4 August 2025
Our Ref: 22379A.2KM_SUB

**Re: Objection to SSD-75660711 - Crows OSD Site A – Detailed SSDA
32 Hume Street, Crows Nest**

Figure 4 Building Separation study prepared by Smart Design Studio showing proposed Tower 1 (right of image) relative to a future building on our Client's Land (left of image).

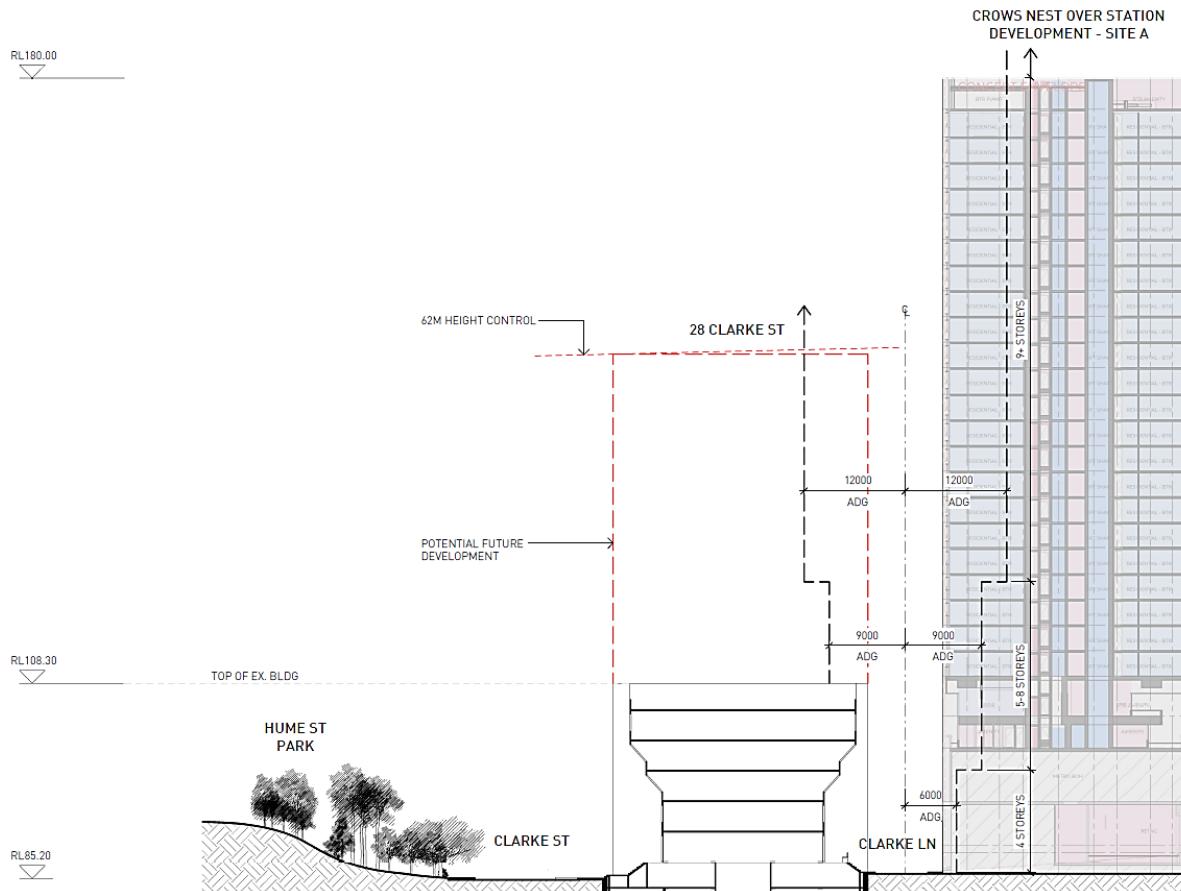
Along the eastern elevation, Tower 1 includes five (5) apartments at each level with habitable rooms and outdoor terraces facing our Client's Land. Across the 13 storeys above the height of our Client's existing building (i.e. up to the 62m height limit applying to Our Client's Land) this equates to 65 apartments facing our Client's Land.

As can be seen in **Figure 3**, the Development Site boundary is defined by a dashed red line and we estimate that the distance between the eastern site boundary and Tower 1 to be approximately 2.5m. However, the Development Site boundary is not identified on the Applicant's elevations or section drawings, of which an extract is included in **Figure 4** above.

Accordingly, it is unclear from the proposed plans and elevations, where the eastern façade of Tower 1 sits relative to the eastern boundary of the Development Site.

We recommend that DPHI clarify this - if the proposed Tower 1 has no setback to the eastern boundary of the Development Site, the adverse impacts on our Client's Land will be exacerbated.

In our opinion, it would be reasonable to take the centreline of Clarke Lane (as depicted in **Figure 4** above) as the datum from which building separation controls should apply to development on both parcels of land. That is, both sites could reasonably utilise 3.0475m of the laneway toward the required building separation under the ADG.

The ADG requires a distance of 9m at 5-8 storeys and 12m above 8 storeys. With a boundary setback of only 2.5m, Tower 1 provides for a setback from the centreline of the lane of only 5.5475m at all residential levels of the proposed building.

As shown in **Figure 4**, this would result in a situation where a future tower on Our Client's Land that was compliant with the ADG requirements (i.e. half the width of the required building separation) would be setback 14.5475m at 5-8 storeys (instead of the required 18m) and 17.5475m above 8 storeys (instead of the required 24m).

1. **Provide a greater eastern setback for Tower 1, in full or in part, to increase the building separation from a future tower on our Client’s Land and provide for an equitable distribution of building separation across both sites;**
2. **Amalgamate the smaller, east-facing apartments (Type 1B2, Type 1C2 and Type 1D) with the corner apartments (Type 1E and Type 2E) at Levels 4-16 to reduce the number of apartments directly facing our Client’s Land. This would also increase the ADG solar access and natural ventilation compliance of the proposed development and provide more 3-bedroom apartments; and**
3. **Redesign the windows and wintergardens at Levels 4-16 to have oblique outlooks (north or south) and privacy screening, rather than a direct outlook toward our Client’s Land.**
